CU-DAR001 Dart Helicopters Services	Drawing Name	: PLUG
: 46101		
Material Number : 12322	Part Number	: D34921
P.O. Number :	Drawing Number	: D3492 REV C
This Issue : 27/02/2009 S.O. No. :	Project Number	: N/A
Prsht Rev. : NC	Drawing Revision	: C
First Issue : / / Type : MACHINED PARTS	Material	:
Previous Run : 45561	Due Date	: 06/03/2009 Qty: 80 Um: Each
Written By :		
Checked & Approved By : <u>JUD 09.02.27</u>		
Comment : est rev A 06.03.03 New Issue EC		
Est Rev:B 06-08-28 As per Rev B JLM		
Est Rev:C 07-12-06 Rev C dwg DD verified by:EC		
Est Rev:D 09-02-18 remove o'ring DD

Drawing Name: PLUG

DRAWING NO. D3492	TITLE PLUG	REV. C	DART AEROSPACE LTD ENGINEERING ORDER		D.E.O. NO. D3492-C-1	SHEET NO. SHEET 1 OF 1	SCALE NTS
DRAWN AJS	CHECKED <i>[Signature]</i>	MFG. APPR. <i>[Signature]</i>	APPROVED <i>[Signature]</i>		DE APPR. <i>[Signature]</i>		
DATE 08.11.05	DATE 08.11.05	DATE 08.11.05	DATE 08/11/05		DATE 08/11/05

D3492-XX PLUG MACHINING DETAILS

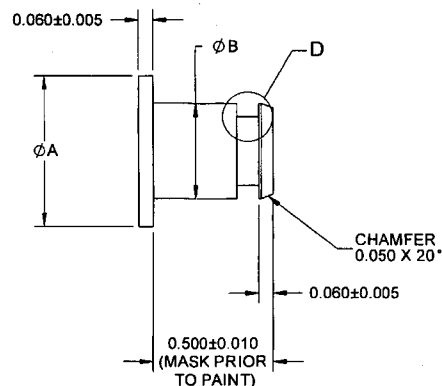
SHEET 2 MODIFY -13 PLUG AS SHOWN:

WAS:

P/N	A	B	C	MATERIAL SPEC
D3492-13	0.750	0.520	0.045	M6061T6R0.750

IS:

P/N	A	B	C	MATERIAL SPEC
D3492-13	0.750	0.510	0.045	M6061T6R0.750
